**CENTER FOR DRUG EVALUATION AND
RESEARCH**

APPLICATION NUMBER:

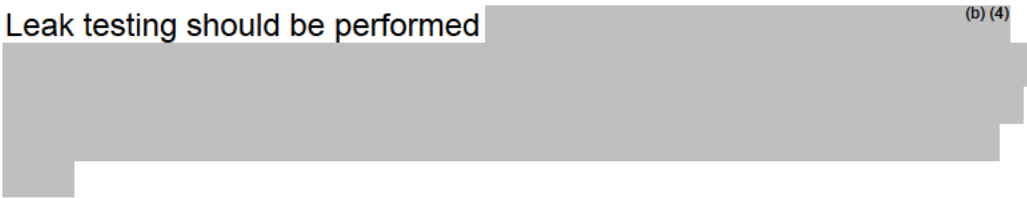
3. In the Genus decision issued on April 16, 2021, the U.S. Court of Appeals for the District of Columbia Circuit held that articles that meet the device definition in section 201(h) of the FD&C Act must be regulated as devices and not as drugs. In implementing this decision, FDA has determined that the language in 21 CFR 200.50(c) indicating that eye cups, eye droppers, and ophthalmic dispensers are regulated as drugs when packaged with other drugs is now obsolete, as these articles meet the “device” definition. FDA will be regulating these products, including your product, as drug-led combination products composed of a drug constituent part that provides the primary mode of action (PMOA) and a device constituent part (an eye cup, dropper, or dispenser). As the drug constituent part provides the PMOA, CDER will have primary jurisdiction over these products, including your product. For each submission for this application, indicate that the product is a combination product in field #24 of the FDA Form 356h. Additionally, please refer to the Guidance for Industry, Identification of Manufacturing Establishments in Applications Submitted to CBER and CDER, Questions and Answers, from Oct 2019. For combination products, facilities manufacturing a constituent part of a co-package or single entity combination product, or drug-device combination product that are proposed to be involved in the disposition of commercial product should be included on Form 356h. This includes final kitting facilities and facilities that conduct design control activities, including verification and validation, of a device constituent part.
